Application for Disposal Works Construction Permit

Re: Variances for Failing Septic System at 117 Middle Street,
Amherst

RE: Repair of a private septic system
117 Middle Street
South Amherst, MA

SHEET TITLE
SUBSURFACE WASTEWATER DISPOSAL
SYSTEM REPAIR

PLAN SCALE
1" = 20'

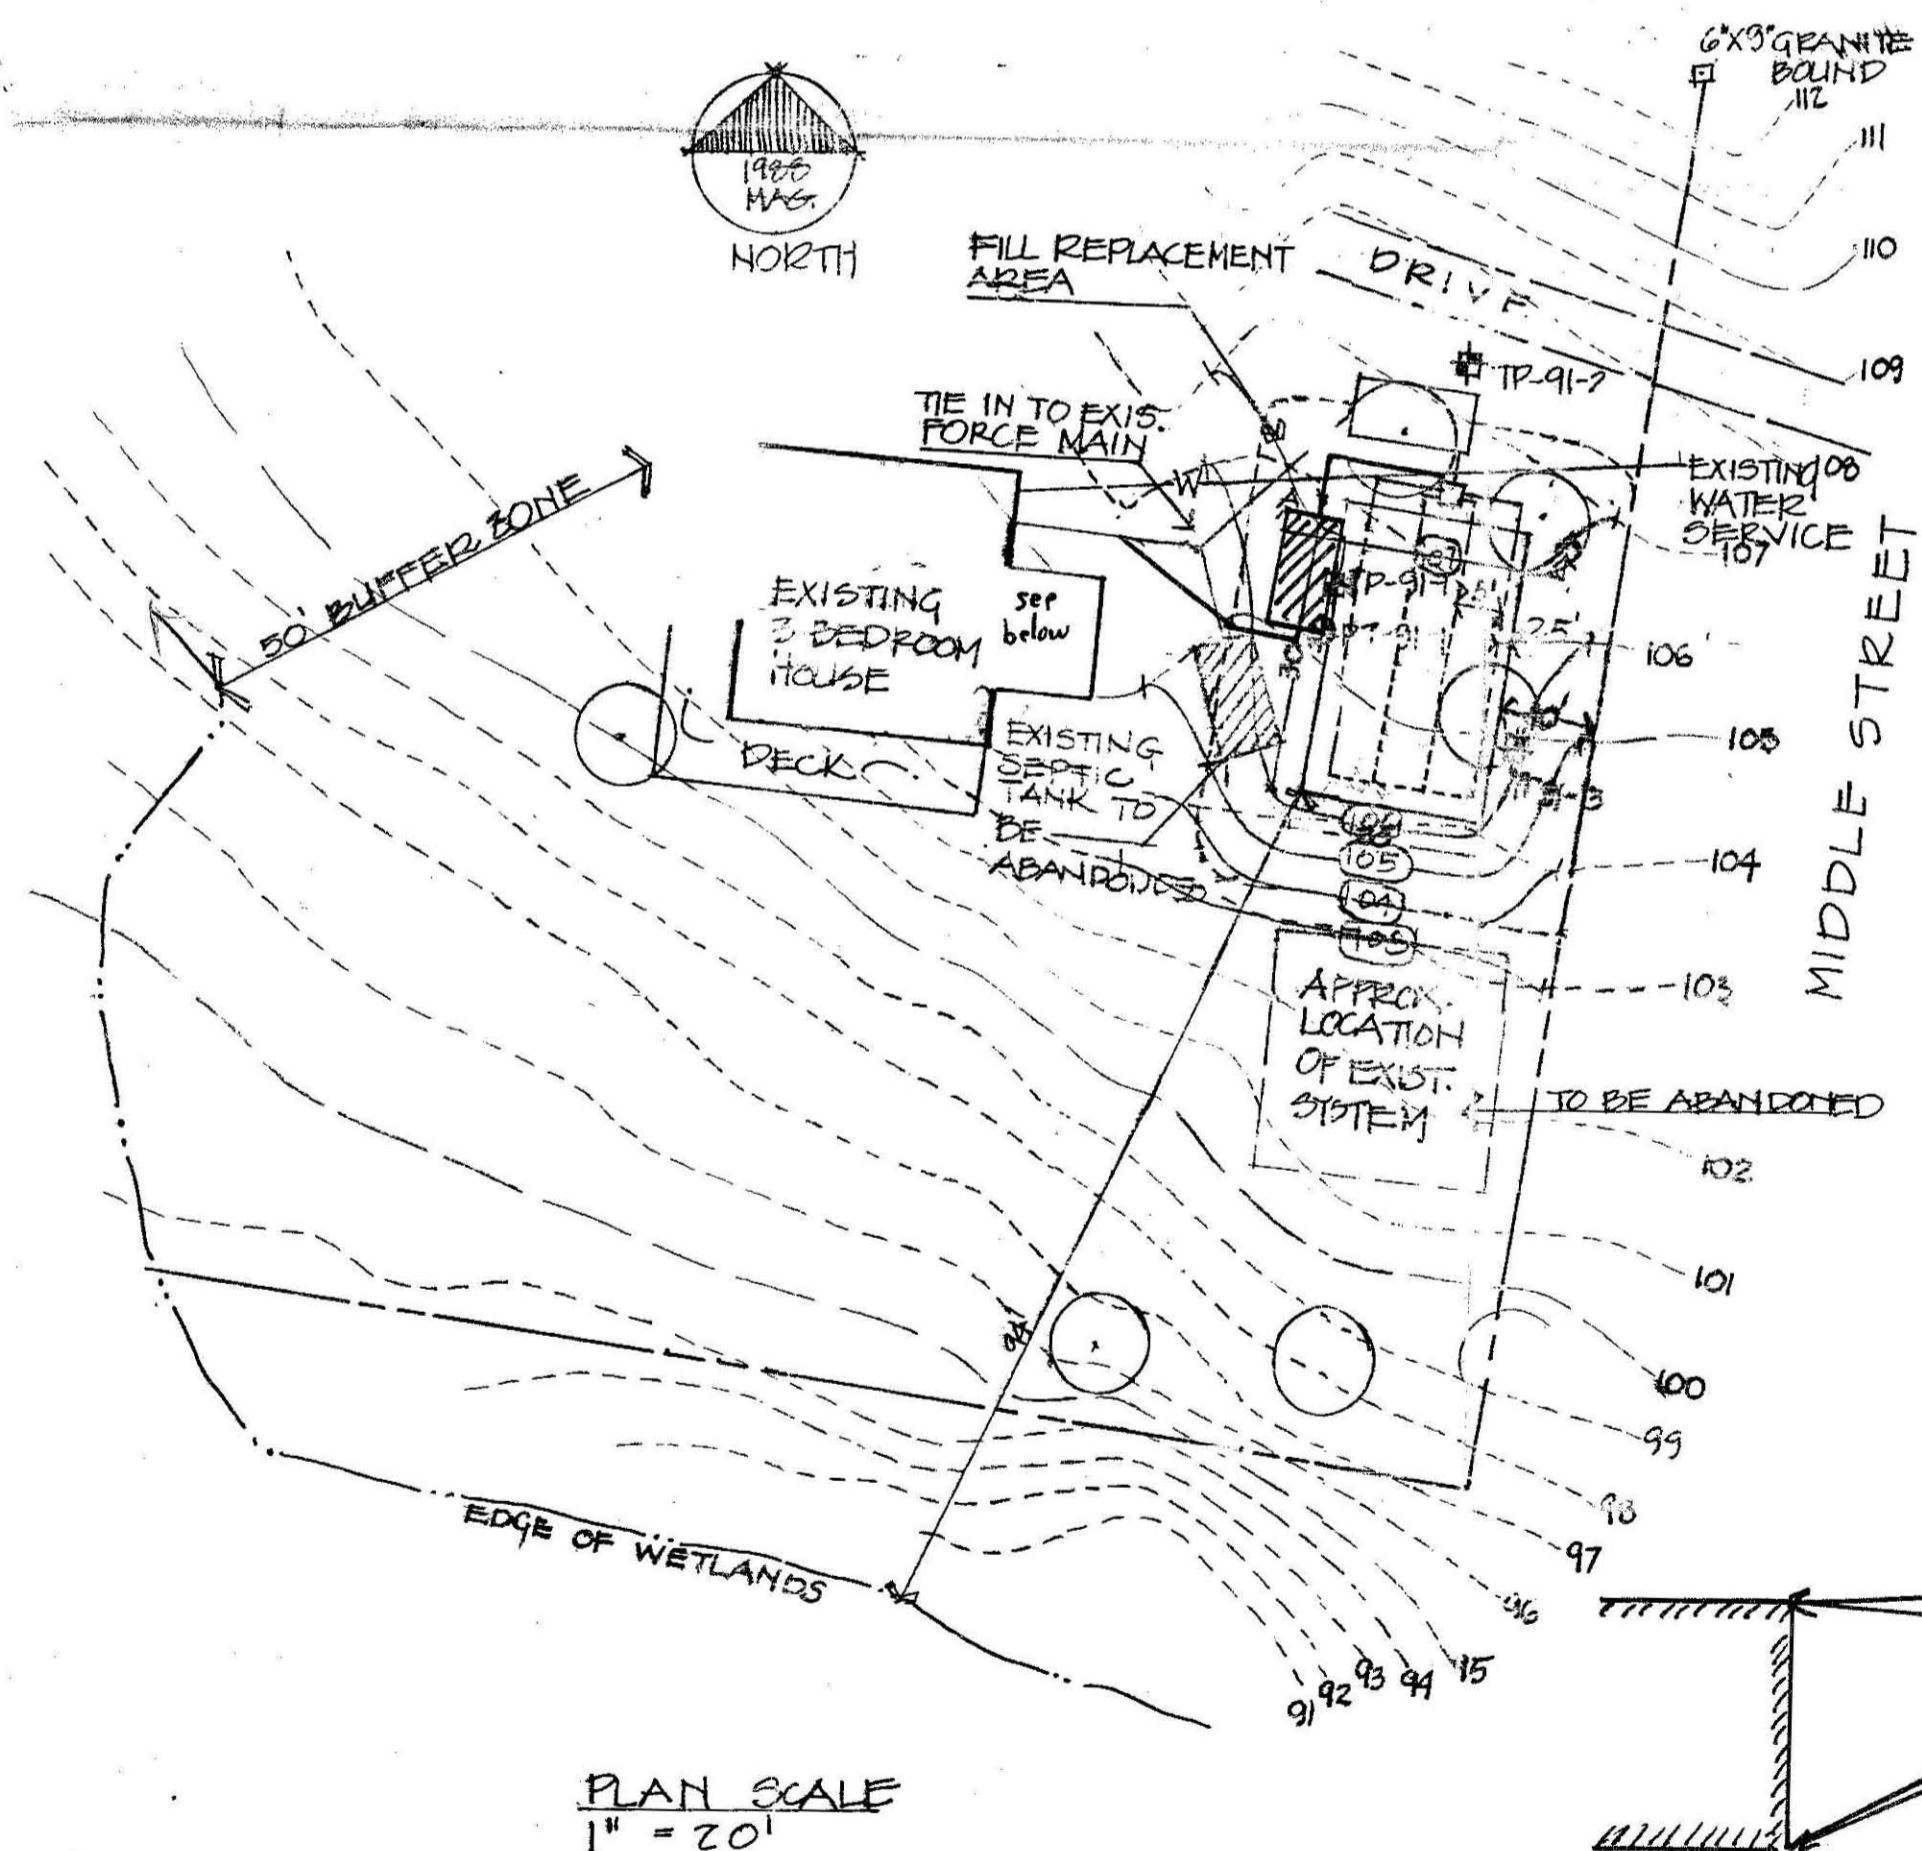
1. Section 2 - General Requirements - Reference 15.02 (13). Town requires the size of the leaching area: not to be less than 1 1/4 times the minimum area as determined by the state calculations.
2. Distances - Reference 15.03 (7). Private sewage disposal systems shall not be located nearer than 100 feet from any watercourse, stream or pond.

My only concern is that the engineer (Walter Schwartz) made note of oxide stains in the deep holes. In the past, I have used the oxide stain as a means of high water table. If we use the 3 foot oxide stain as a guide, than this septic system plan can not be approved as designed. If we use Professor Veneman's data, the system can be installed and only the Town variances noted would have to be adressed.

VARIANCES REQUESTED

1. LEACHING FACILITY SHALL BE 100' FEET FROM WETLAND BOUNDARY. 94' PROVIDED

2. SIZE OF LEACHING FIELD SHALL BE AT LEAST 1.25X TITLE II REQUIREMENTS. FULL TITLE II AREA PROVIDED TO AVOID NEED FOR STATE VARIANCES DUE TO SETBACKS

Unanimous agreement to grant a variance to the town's requirement for size of leaching area and distance for a private disposal system to any watercourse, stream and pond. Also with the condition that the garbage grinder be removed. It is the Board's opinion that the same degree of environmental protection can be achieved without strict application of this particular provision.
